# Car Stereo Service Bulletin

**CSA-14**

**Model:** CDX-U300RF/U500RF; RM-X14      **No. 304**

**Subject:** Displayed Time May Lose Or Gain Several Minutes Per Month.      **Date:** October 19, 1993

MOUNTING DIAGRAM

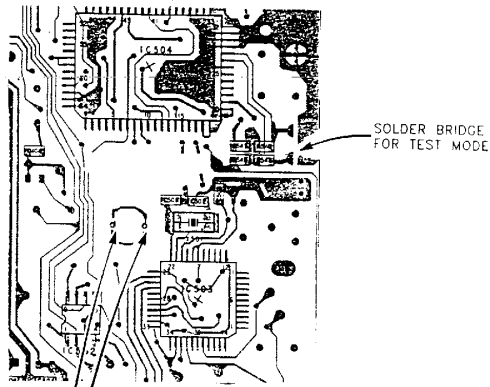
**Symptom:**  
(13) The time shown on the display may lose or gain several minutes per month.

- 1- Change C508 and C509 from 22 pF to 10 pF.
- 2- Add a trimmer capacitor as shown in the drawing.

- 1- Put the unit in the test mode by adding a solder bridge as shown (this solder bridge grounds pin 27 of IC504).
- 2- Adjust the trimer capacitor so that the frequency measured on pin 40 of IC504 is 16.384 KHz.
- 3- Release the test mode by removing the solder bridge.

MOUNT TRIMMER  
CAPACITOR HERE
